**APPENDIX 11 – Chevrolet S-10 Service Bulletins**

*Electric Transportation Applications*

**Subject: Replacing Refrigerant Label**

**Models: 1997-98 Chevrolet S-10 Electric Truck**

Figure 1 - Accumulator Label Location

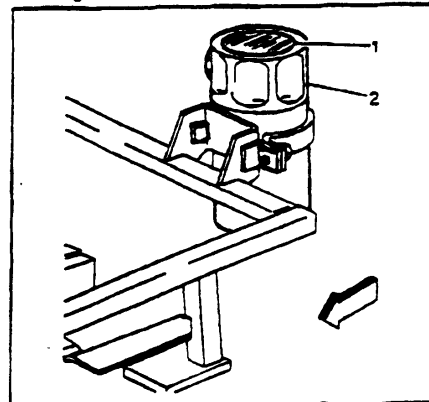
On 1997-98 S-10 Electric Trucks, the existing refrigerant label on the evaporator and blower motor assembly shows an incorrect refrigerant oil part number. The correct refrigerant oil part number is Z7002486.

1. Remove the old label from the accumulator, if equipped. Use a utility knife or remove improper refrigerant specification wording from the label (Figure 1).
2. Remove the existing refrigerant label, GM P/N 52474699, from the evaporator and blower assembly.
3. Clean the label surface area on the evaporator and blower motor assembly before affixing the label.
4. Affix the new label on the blower motor housing. Position the label so that the label can be read from the front of the vehicle (Figures 2, 3).

Replace the existing refrigerant label, GM P/N 52474699, with a new label on the evaporator and blower motor housing. Use the part number listed below. Use the following Service Procedure in order to replace the label:

Figure 1 - Caution Label Installation

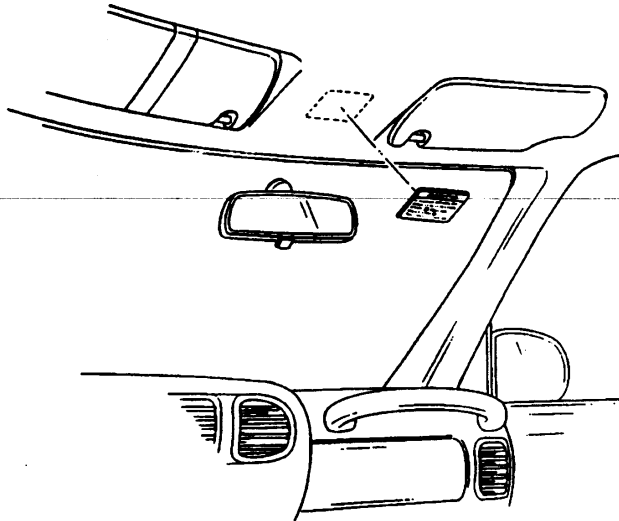
**WHAT WE WILL DO:** To remind drivers of the "stop and wait" procedure, we are enclosing a caution label for installation on your vehicle and a supplemental insert for your owner's manual. You should install the enclosed caution label on your vehicle according to the attached instructions or your Chevrolet dealer will install it for you at no charge.

1. Insure mounting surface is clean.
2. Install caution label on headliner centered between visors as shown in Figure 1 below.
